**ZONING BOARD OF APPEALS**  
**Regular Meeting Agenda**  
**Wednesday April 2, 2025**  
**6:30 P.M.**

**CHARTER TOWNSHIP OF YPSILANTI**  
**ZONING BOARD OF APPEALS**  
**Wednesday, February 5, 2025**  
**6:30 PM**

<b>Applicant:</b>	Charles Paisley of UPH Ypsilanti Property LLC
<b>Project Name:</b>	Culver's Restaurant
<b>Plan Date:</b>	Site Plan: December 20, 2024
<b>Location:</b>	1410 S. Huron St.
<b>Zoning:</b>	TC – Town Center – Form Based District
<b>Action Requested:</b>	Variances for front setback, service lane/parking in front yard, and deficient glazing on facades facing S. Huron St.

**SITE LAYOUT PLAN**  
**CULVERS - YPSILANTI**  
PART OF SECTION 16, T3S, R7E  
YPSILANTI TOWNSHIP, WASHTENAW COUNTY, MICHIGAN

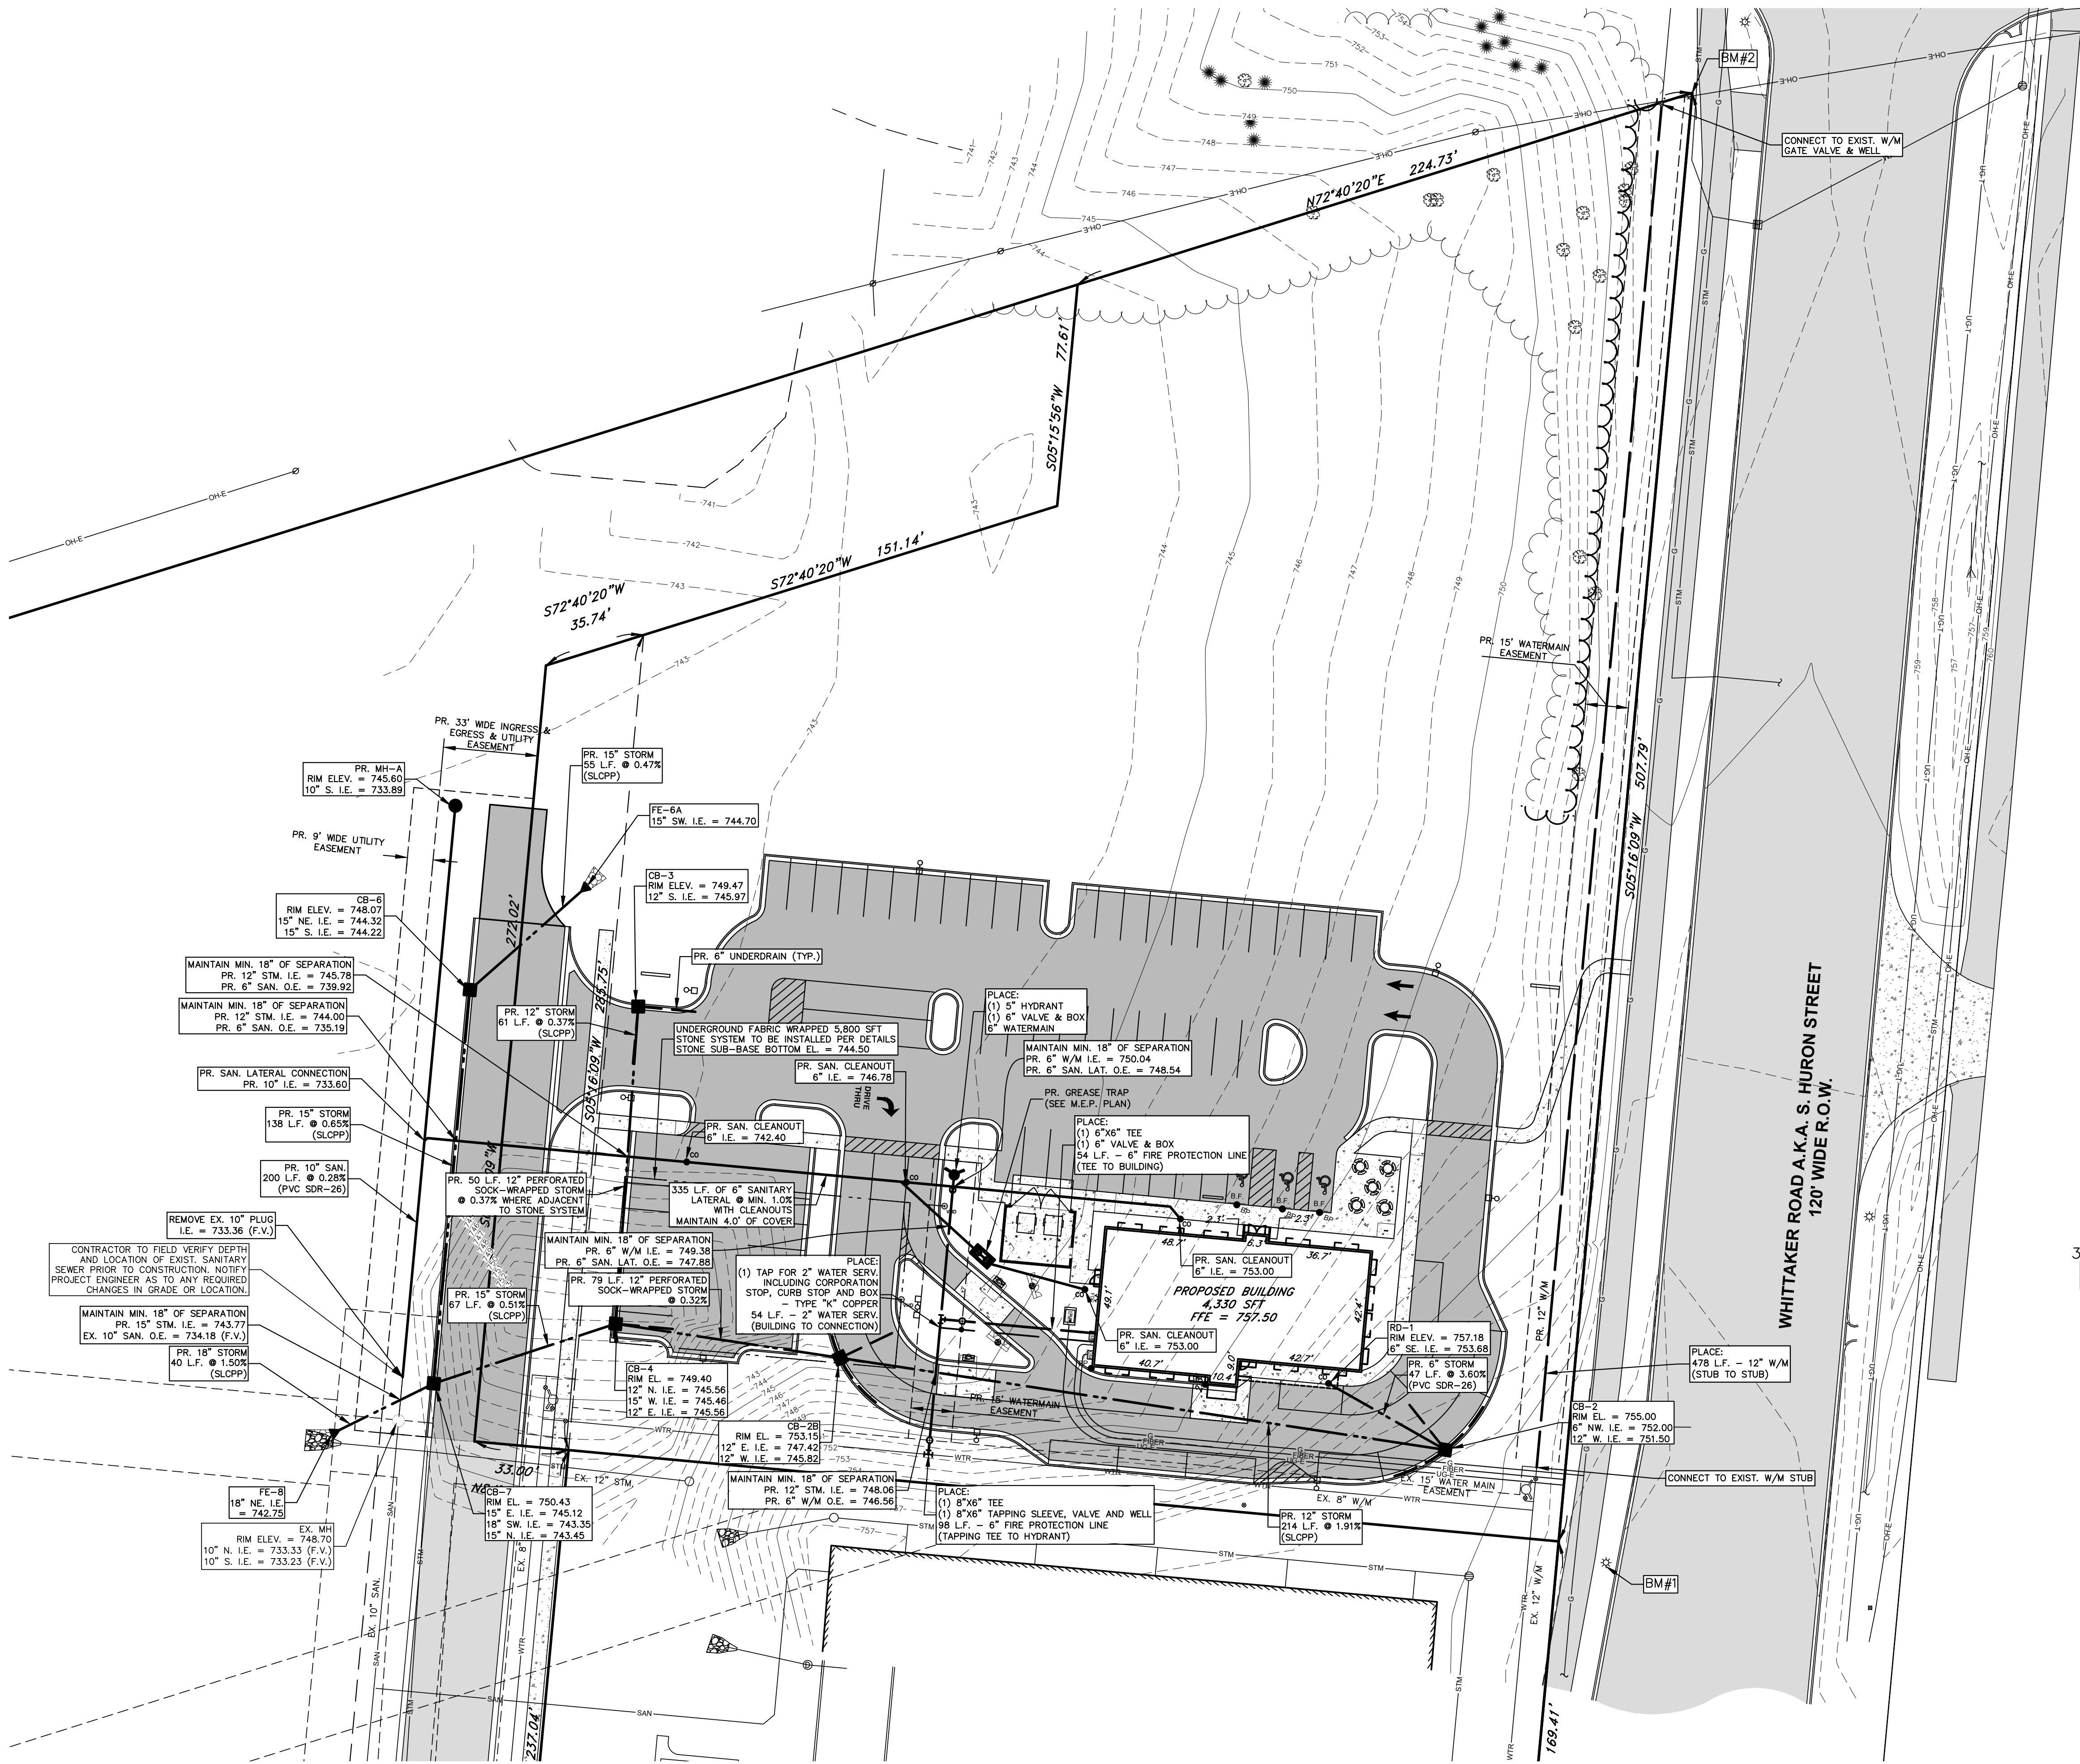
In previous versions of the site design, we discussed some differences between the siting of the Aldi building and the Culver's building. The applicant's response memo explained that the elevation of the access driveway (west side of Aldi) that will extend to Culver's dictates the elevation of the Culver's building to allow acceptable grades for ADA access. The applicant has

worked with the Planning staff to try and meet the form-based requirements. However, they note that due to the significant site topography, the existing elevation of the access road, and watermain easement, moving the building closer to meet the 30-foot setback is not possible. We agree with this assessment.

- B. **Parking in Front Yard along S. Huron.** The site arrangement on this set of plans represents a significant revision from a previous site layout. The previous site layout located the drive-through order boards, three maneuvering lanes, and a few vehicle waiting spaces in the front yard. This revised site layout has substantially reduced these features in the front yard. However, given the limitations presented by the site's topography, and the existing elevation of the access driveway, locating some of these features in the front yard is unavoidable.

- B. **Parking in Front Yard along S. Huron.** See comments above. Also, the Landscape Plan shows that the service lane and vehicle waiting spaces in the front yard will be substantially screened from view of S. Huron St. by new trees and plantings.

DIMENSIONED FLOOR PLAN - METRO L - 2024 PROTOTYPE

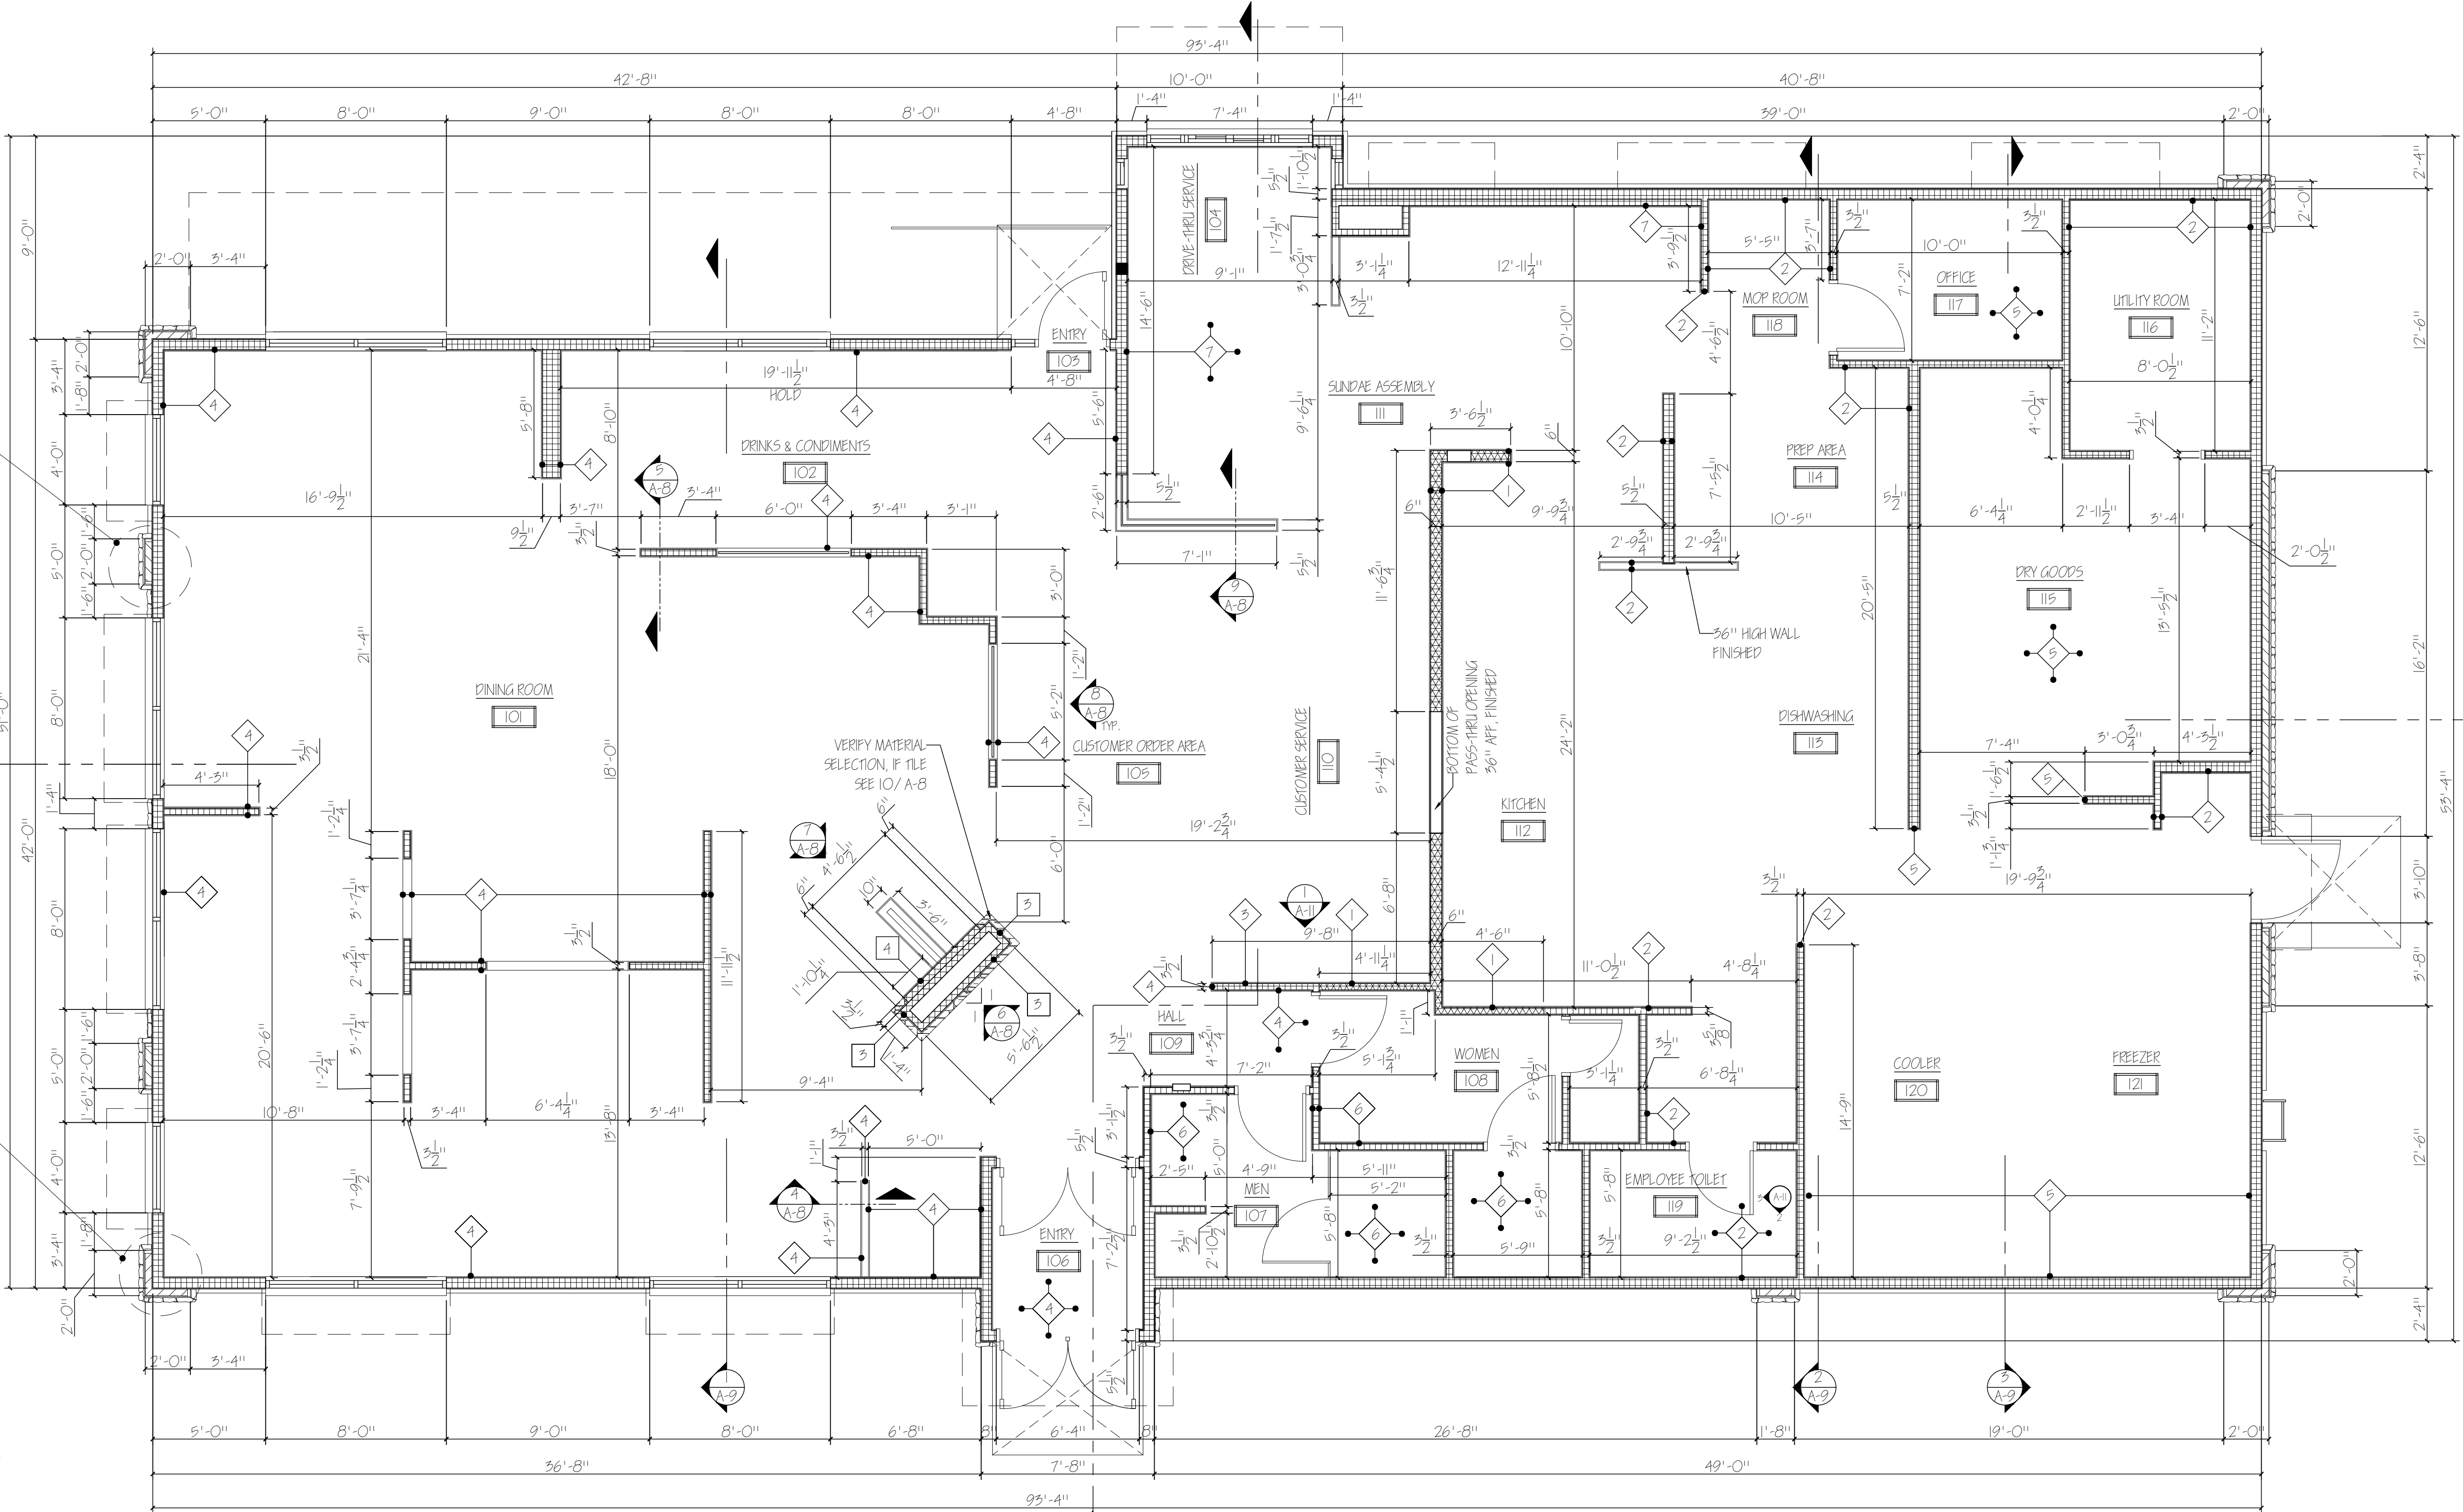
The front building façade of this new building includes six windows. The floor plans show that dining tables line the front façade of the building, allowing diners to see the street, and pedestrians outside to see the activity in the building. One building design feature we think adds to the deficient transparency for this facade is the fact that this wall extends above the first floor by approximately 88 s.f. If this portion of the wall above the first floor were eliminated from the calculation, the windows in this façade would exceed the 50% requirement. We would consider this unique feature of the building to meet this criterion.
